### SANTA ANA RIVER TRUNK SEWER REPLACEMENT PROJECT - PHASE II

# AS-BUILT

## JANUARY 3, 2017

**SANTA ANA RIVER TRUNK SEWER REPLACEMENT - PHASE II**  
**COVER SHEET**

**TUCSON TRUNK SEWER CONNECTION - PLAN VIEW**  
SCALE: 1"=10'

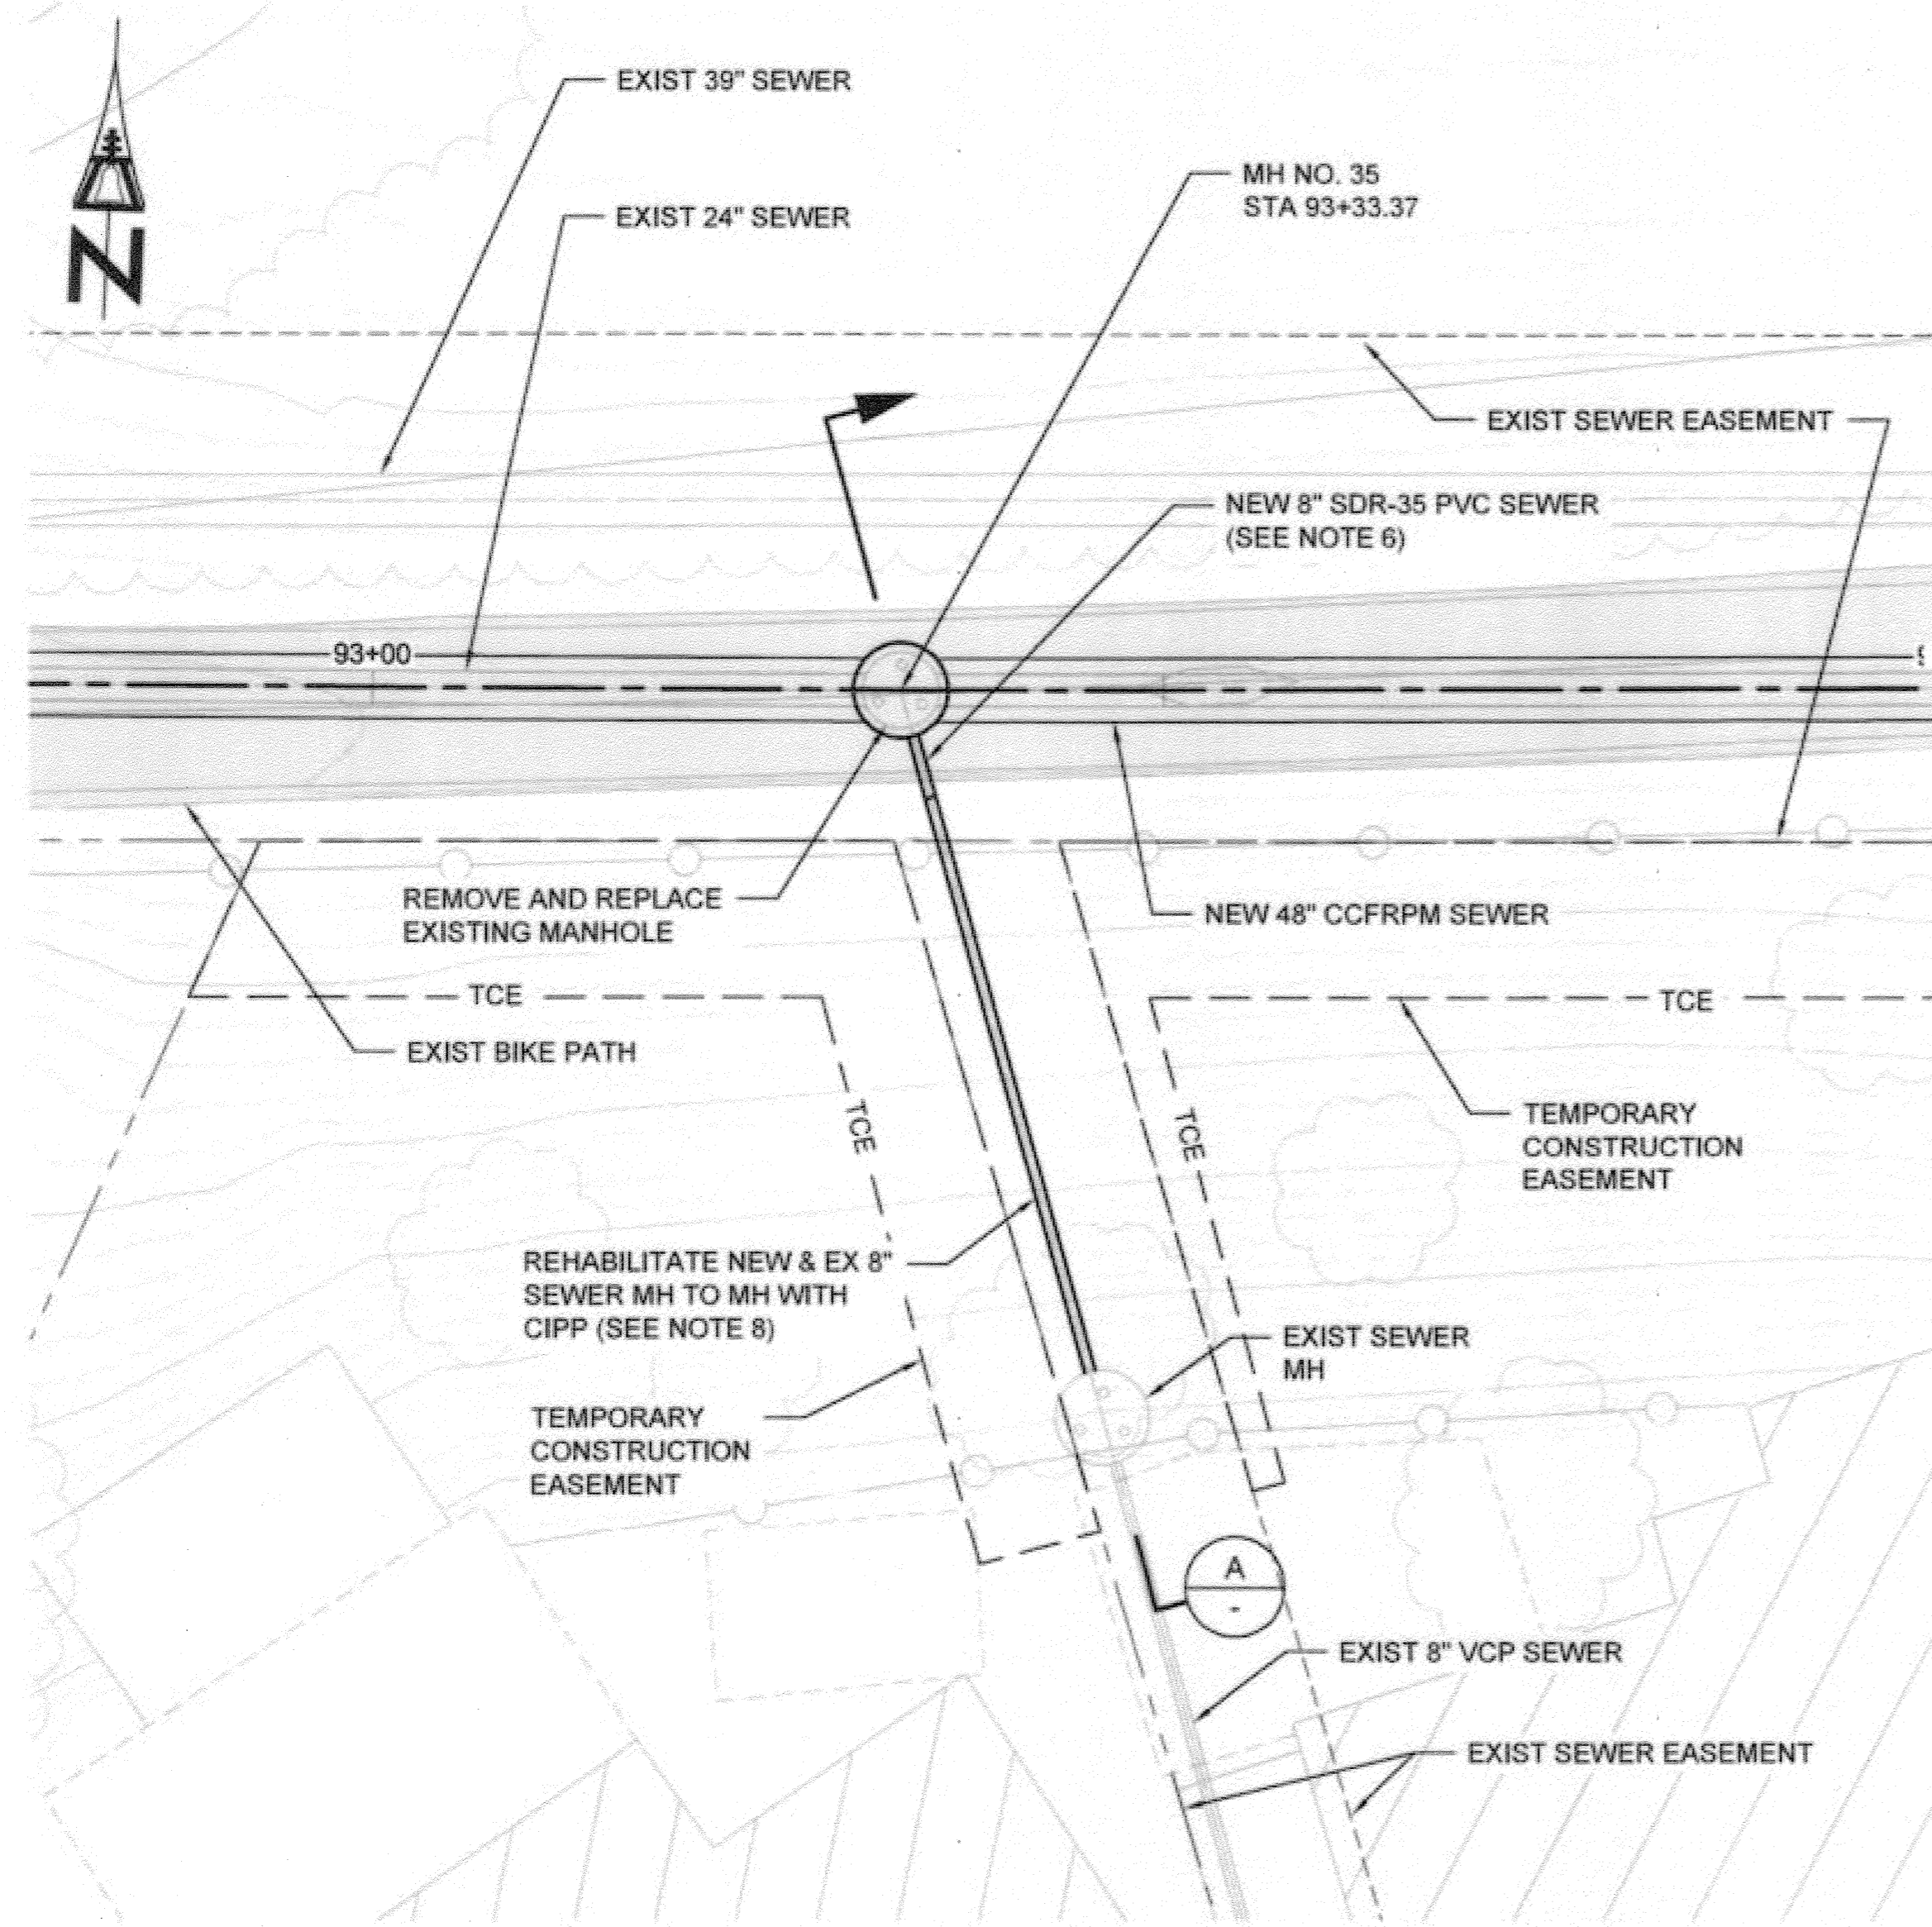
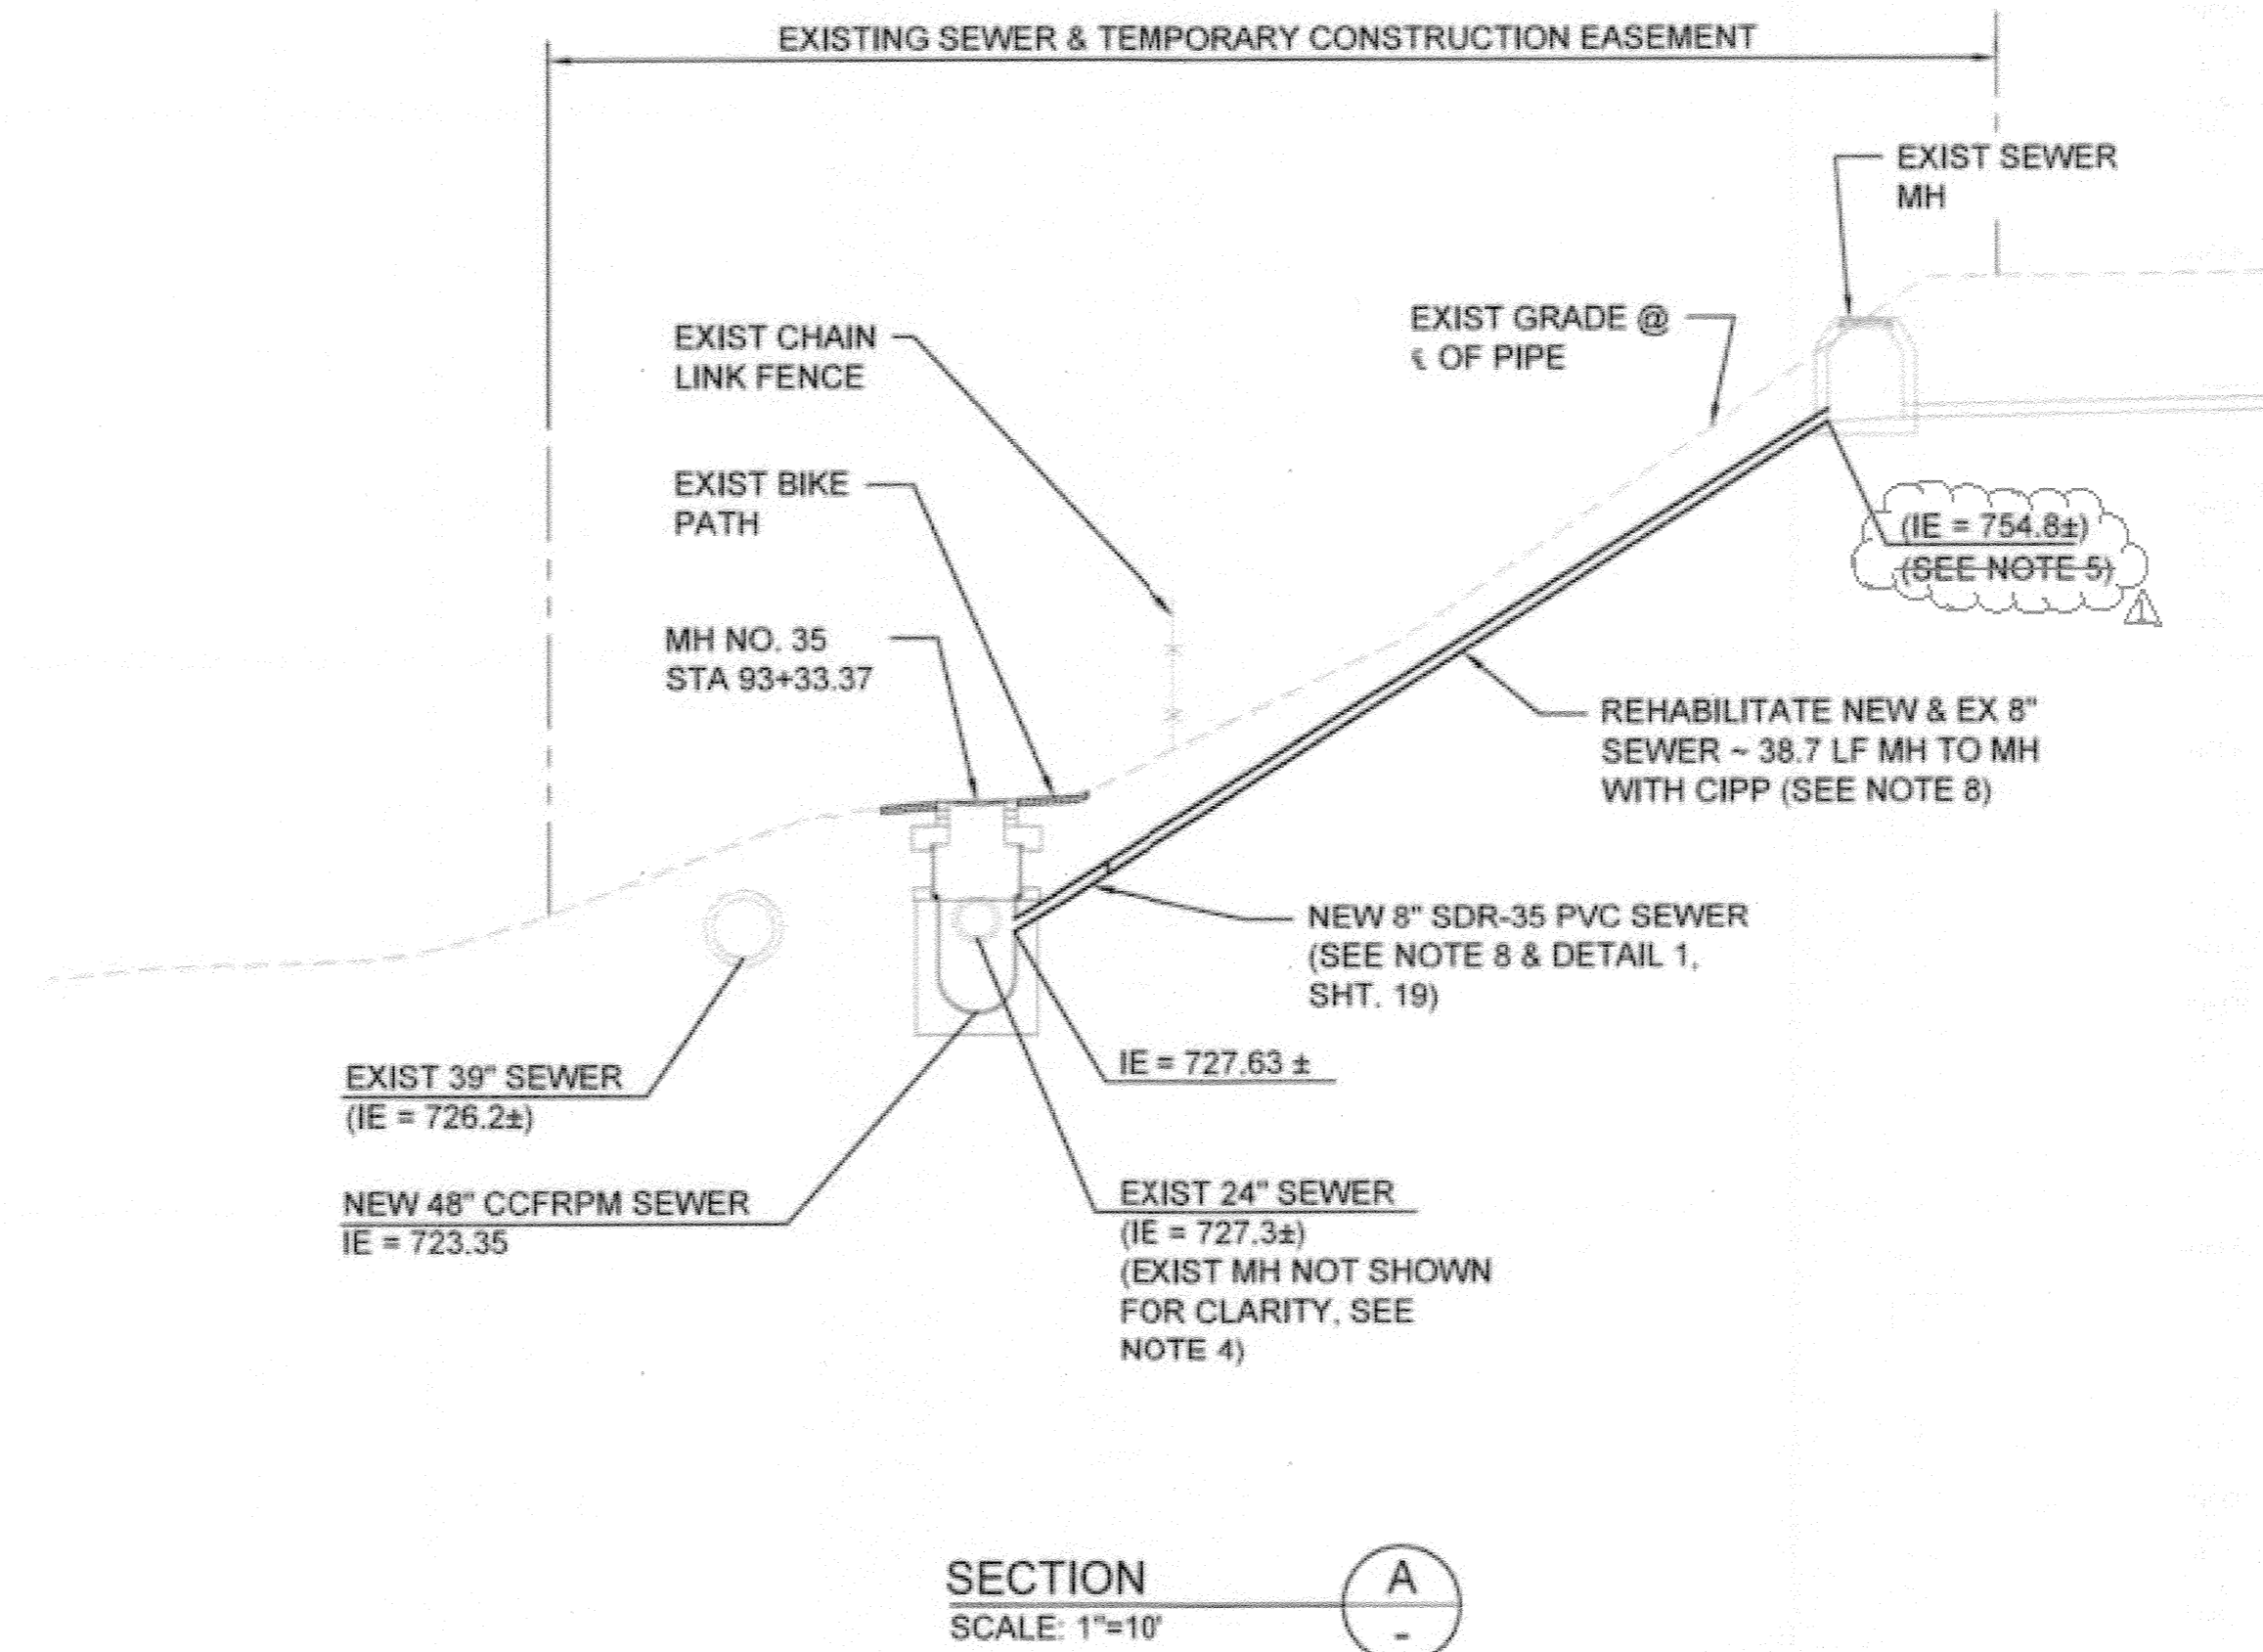
SEE CITY PLAN REVISION No.2
